Re: Development Application DA-2062-31
The Aurora Highlands North - Site Plan
Location: QS:98V,98W,99W,01W – East of Denali Boulevard between 26th Avenue and 48th Avenue
Case Number(s): 2022-4027-00

The Aurora Highlands North

Fire/Life Safety Pre-Acceptance Comments:

THE AURORA HIGHLANDS NORTH - AREA A PRELIMINARY SITE PLAN

TITLE: PHASING PLAN - PA-6

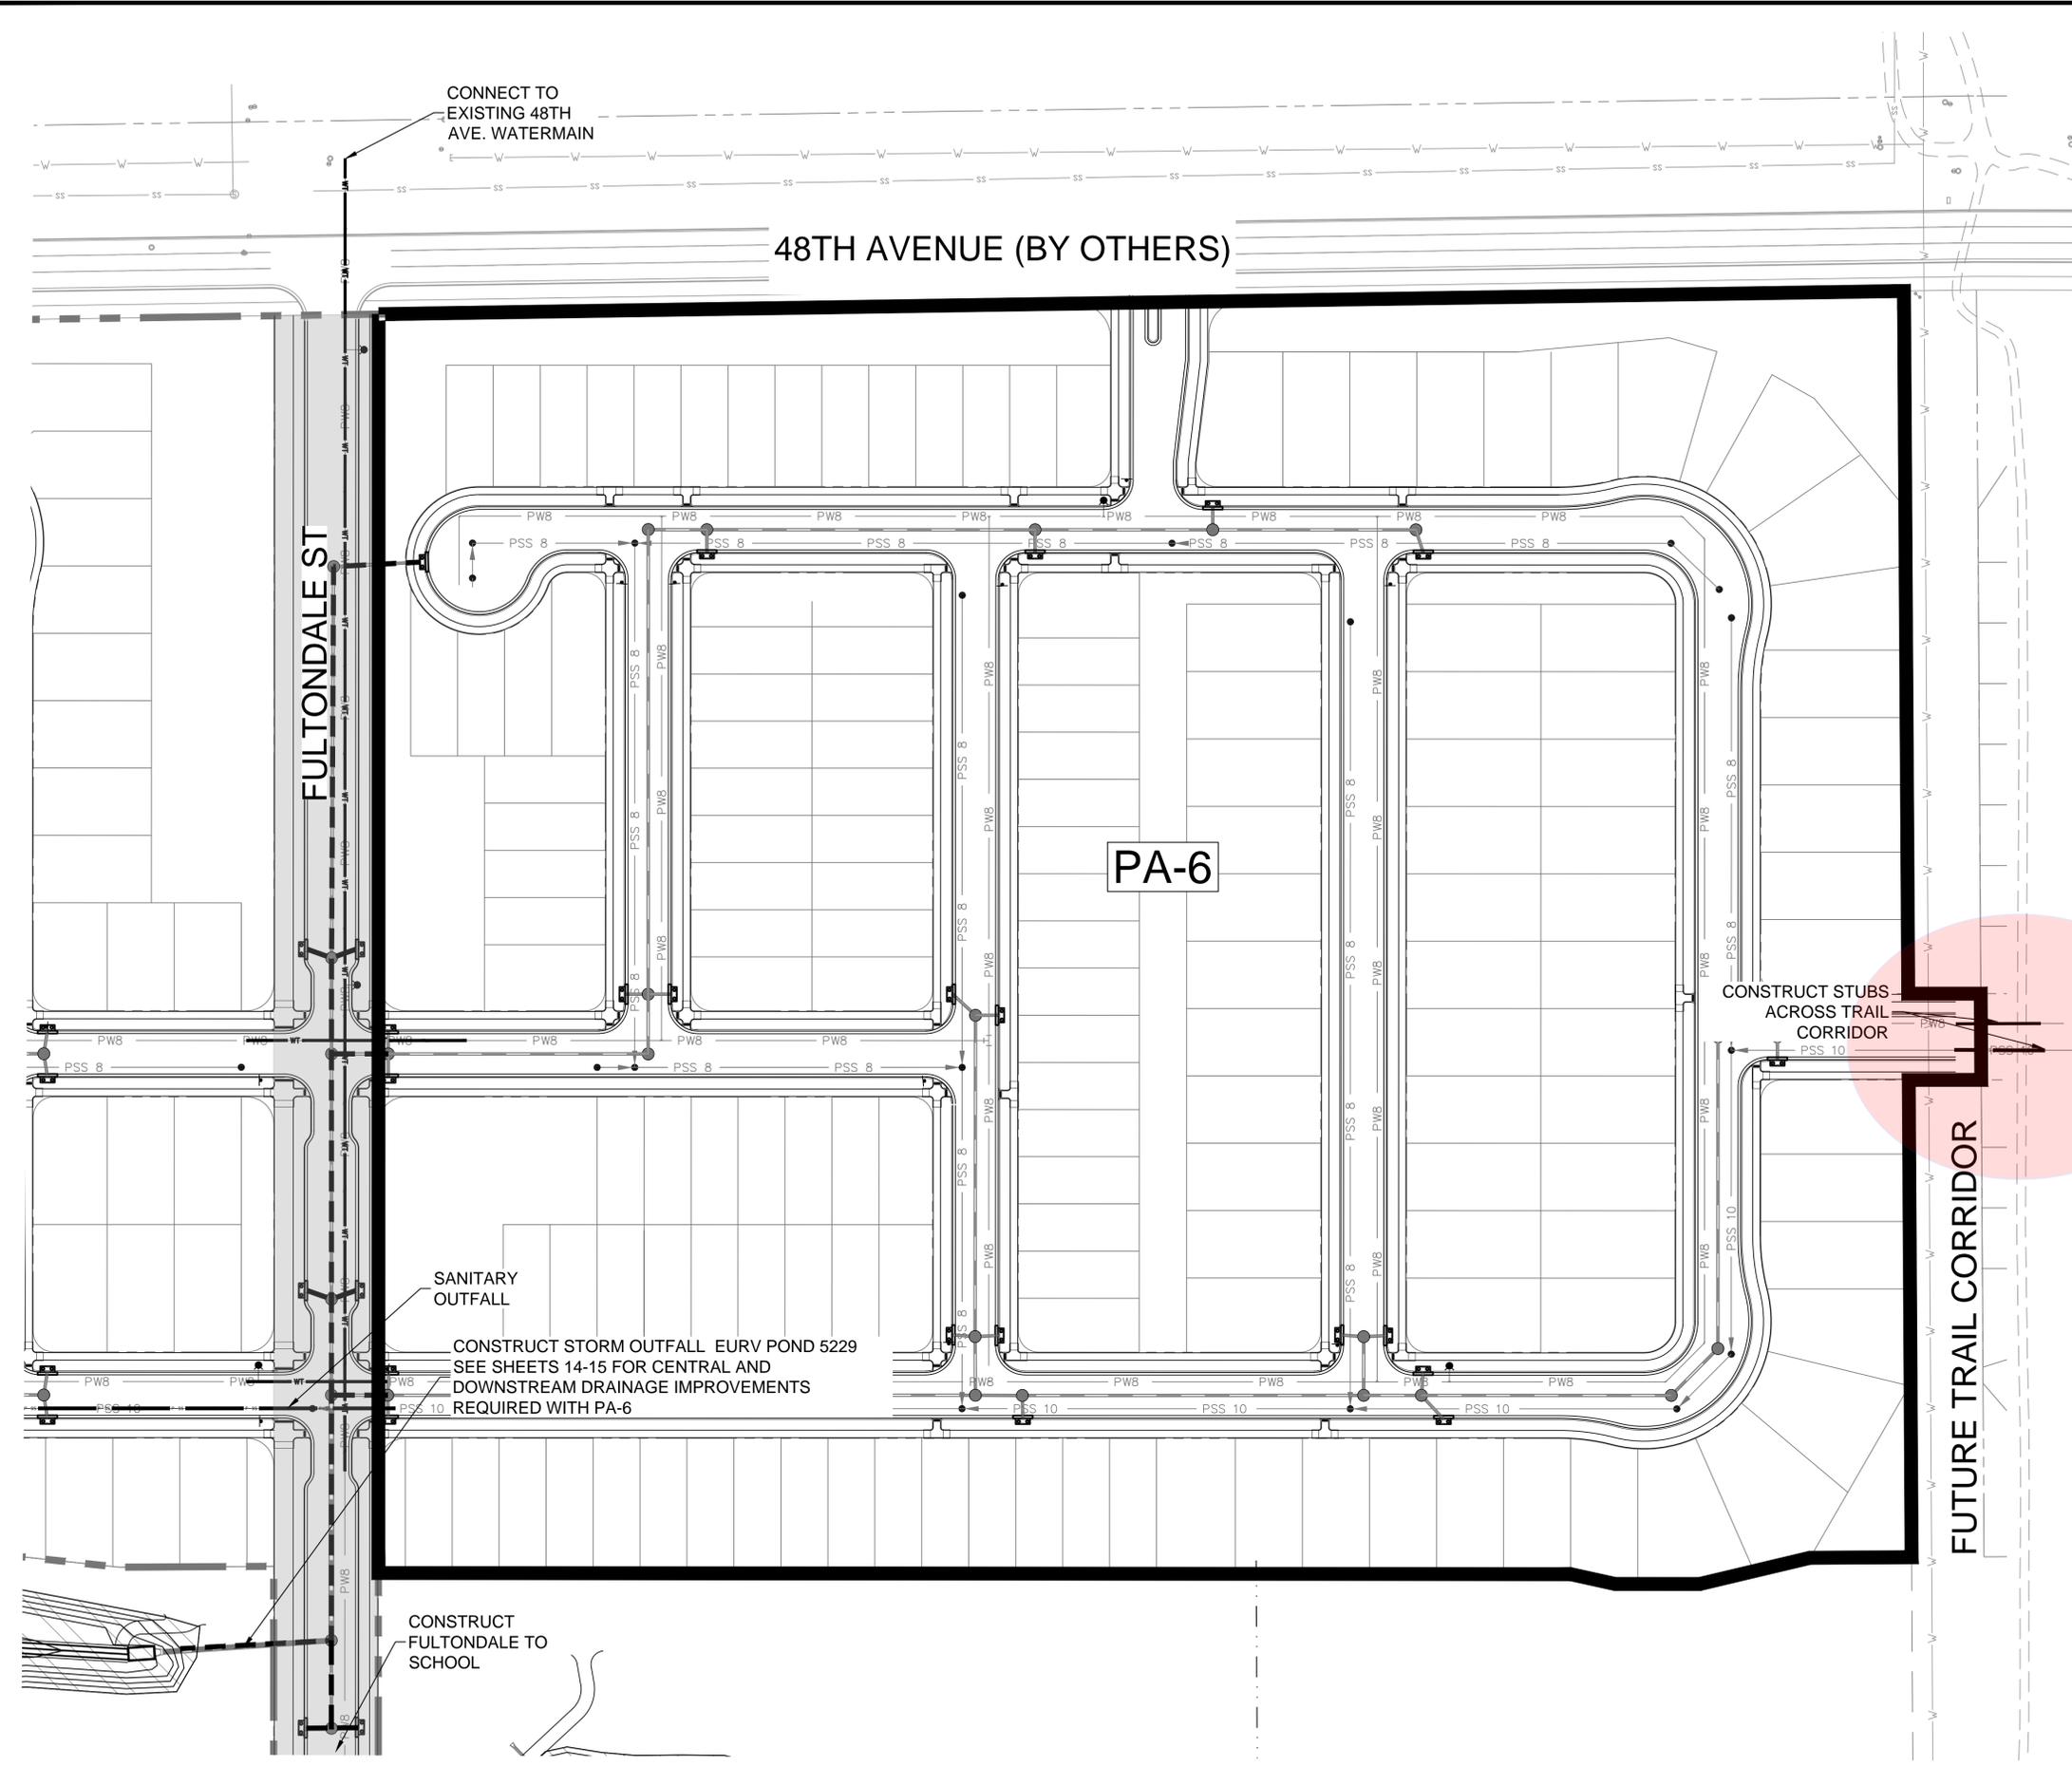
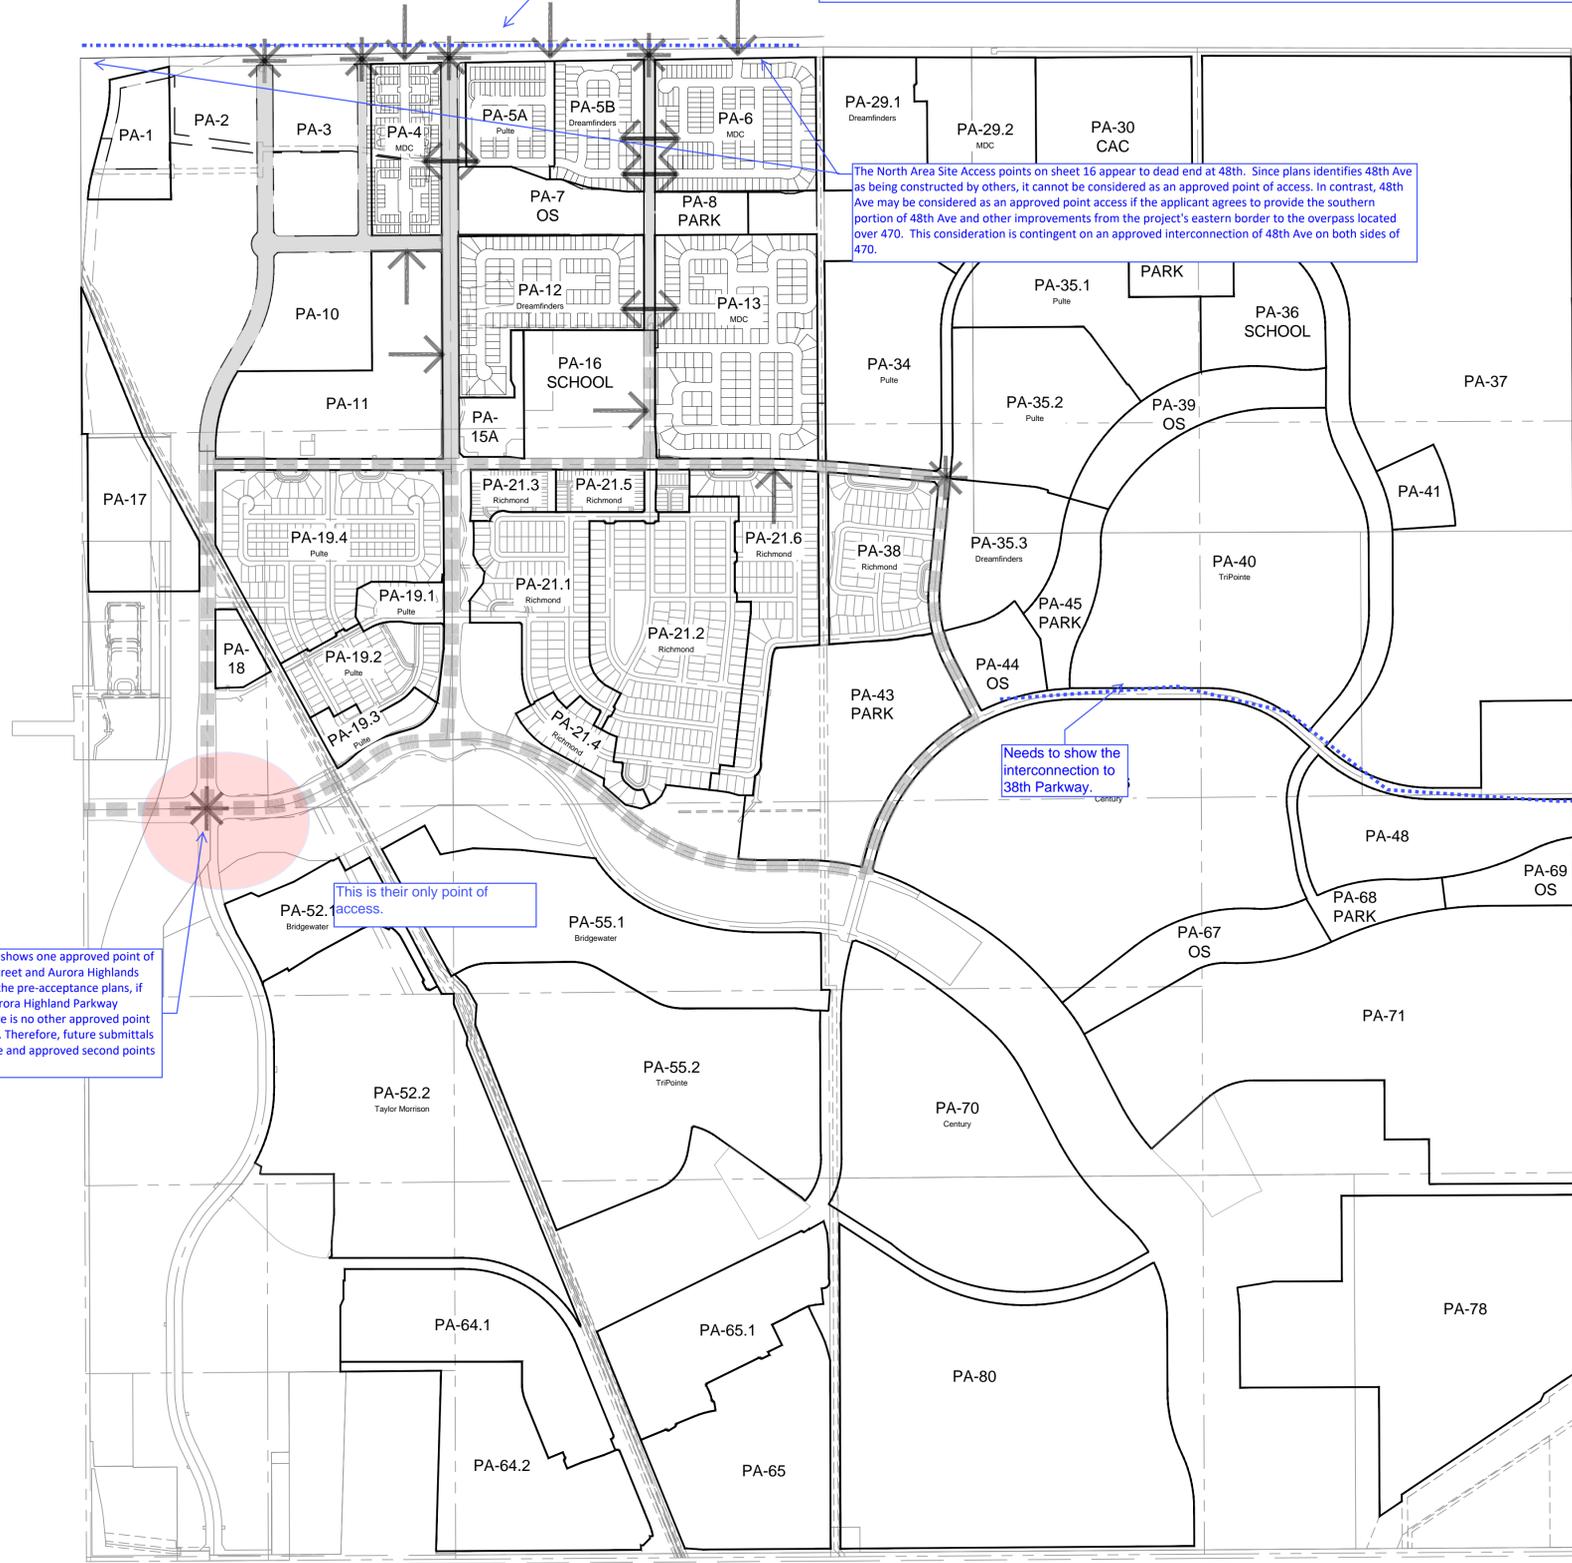
48th is describe as future, therefore is not an approved access point.
